CERTIFICATE OF APPROPRIATENESS

Property: 702 Sul Ross St, Tracts 3, 4, and 5, Block 11, Lockhart Connor and Barziza Subdivision. The property includes a historic 2,170 square foot, two-story brick and wood frame single-family residence and a detached garage situated on an 8,925 square foot (75' x 119') corner lot.

Proposal: Alteration – Addition *Revision*

EAST SIDE ELEVATION FACING GREELY

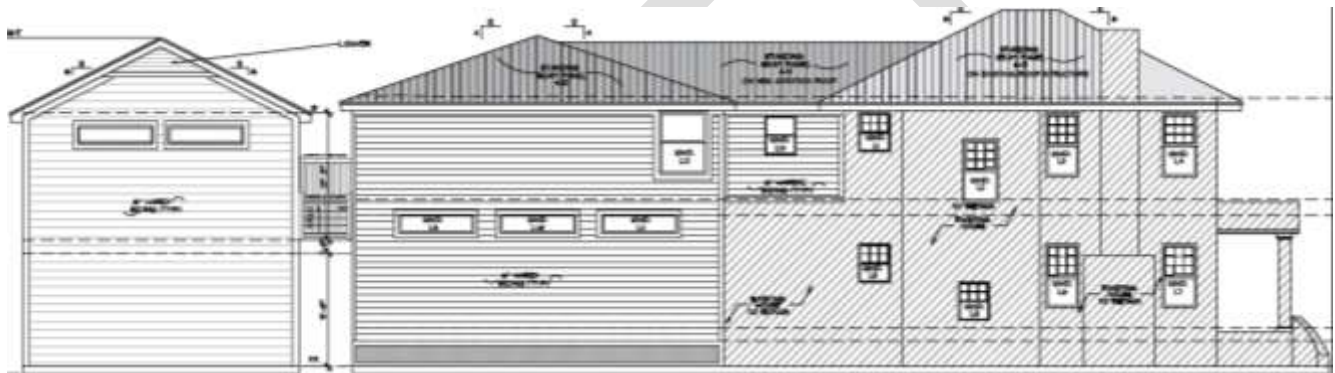
- Construct a deck on the first level of the east (side) elevation facing Greeley. The deck will have a 36" finished floor height to match existing.
- Alter the fenestration pattern on all elevations of the addition, and install a door on the second level of the garage apartment at the stair/landing. See drawings on p. 6-10.

Proposed: The applicant proposes to alter the fenestration pattern on all elevations of the addition. The addition will have fixed and 1/1 windows, as well as single-lite French doors on the first and second level of the east (side) elevation. The applicant proposes to create one additional door opening on the second level of the south (side) elevation of the garage at the stair landing. See drawings on p. 6-10 and window/door schedule for more detail.

Recommendation: Approval

SITE PLAN

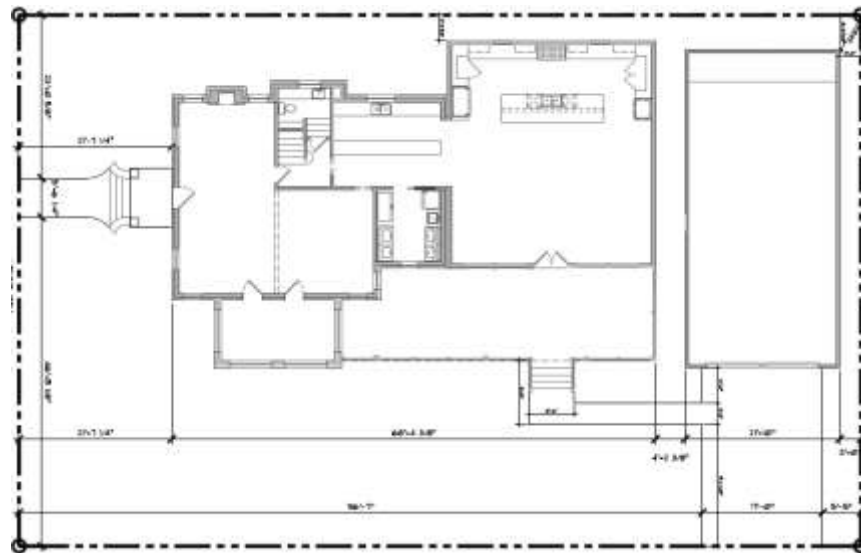
Proposed: The addition will feature a deck on the first level of the east (side) elevation that will measure approximately 13' wide by 44' deep and will be inset 1' from the northeast corner of the sunroom. The addition will connect to the two-story garage with a stair/landing on the second level that will measure 4'-2" deep situated 10' above grade.

FIRST FLOOR PLAN

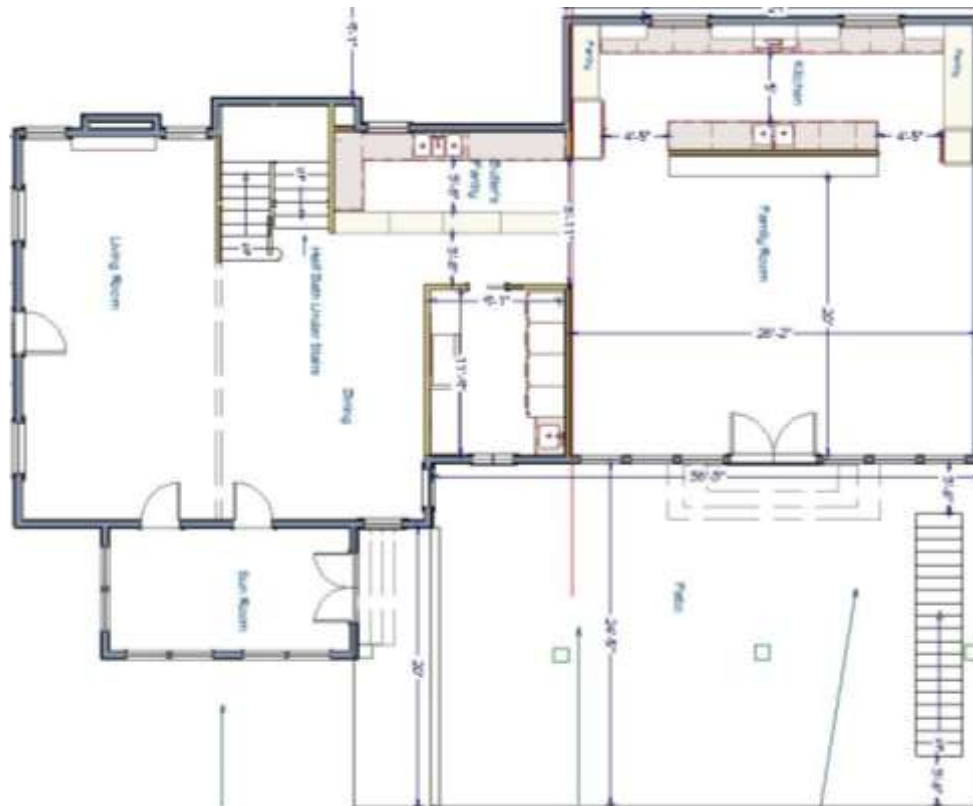
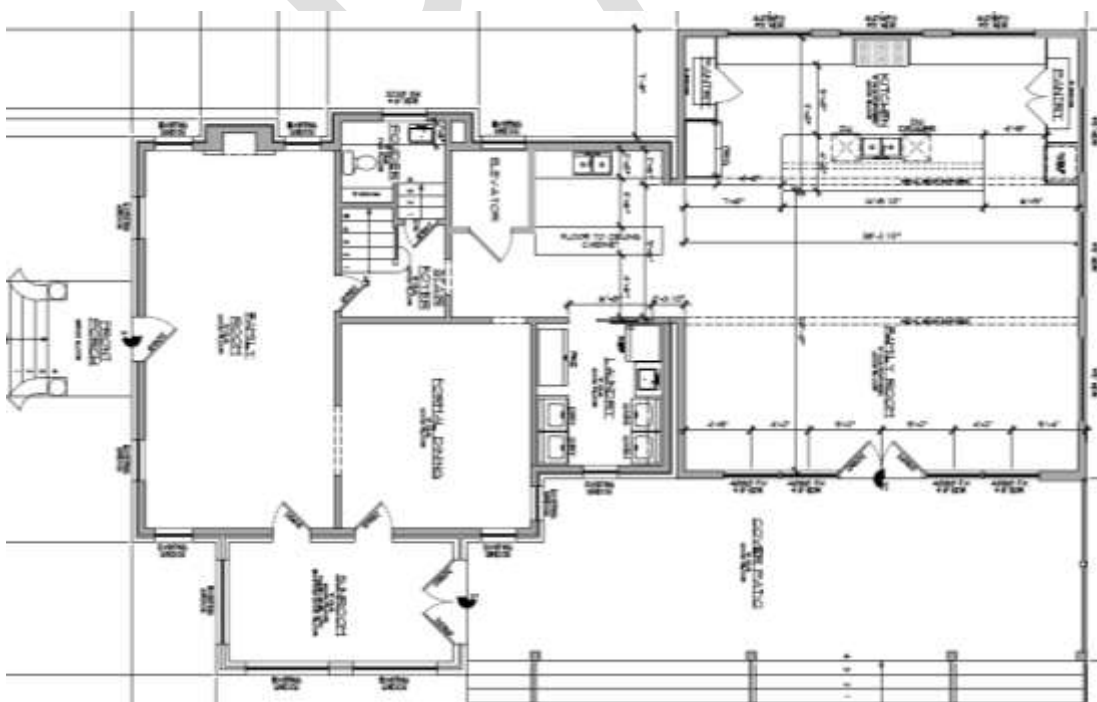
Proposed: The proposed deck on the first level of the east (side) elevation will have a 36" finished floor height to match existing.
